APPENDIX F

Comments on the Draft Environmental Assessment and Responses to Comments

B. Comments and Responses on the Environmental Assessment

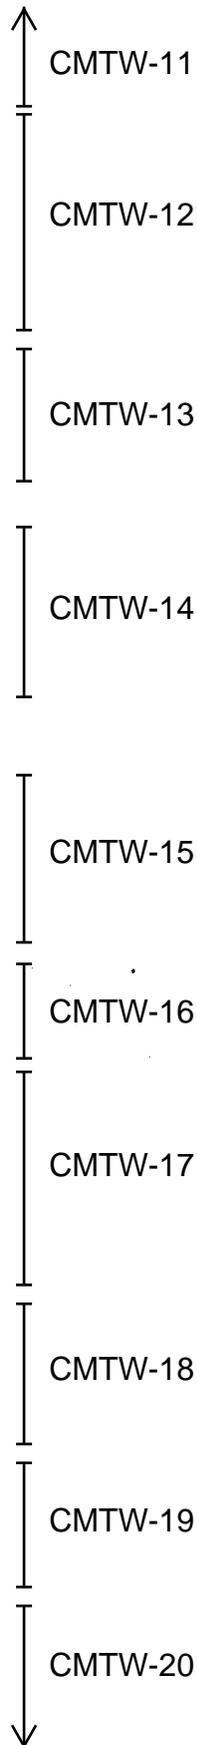
The EA/EIS must provide: a geologic cross section of the three groundwater plumes which converge at the Bevatron site, i.e. Building 51/64 VOC plume, Building 7 Freon/VOC plume and the old town VOC/Building 7 Diesel plume, to show the depth and concentration of groundwater contamination in the four acre Bevatron site and vicinity.

In addition to the Bevatron core area, more monitoring wells should be located laterally along the Cyclotron Fault and New Fault because they could act as conduits for the contaminated groundwater.

Additional groundwater monitoring wells are needed (a) west of the northern lobe of the Building 51/64 plume as well as (b) west of the western lobe of Building 71 solvent plume to show whether the two plumes converge into a topographic swale and (c) west of the old town plume, specifically in the area between Buildings 46 and 51. All of these plumes are in the Blackberry Creek Watershed and drain west toward the city of Berkeley and San Francisco Bay. (Attachment 3.)
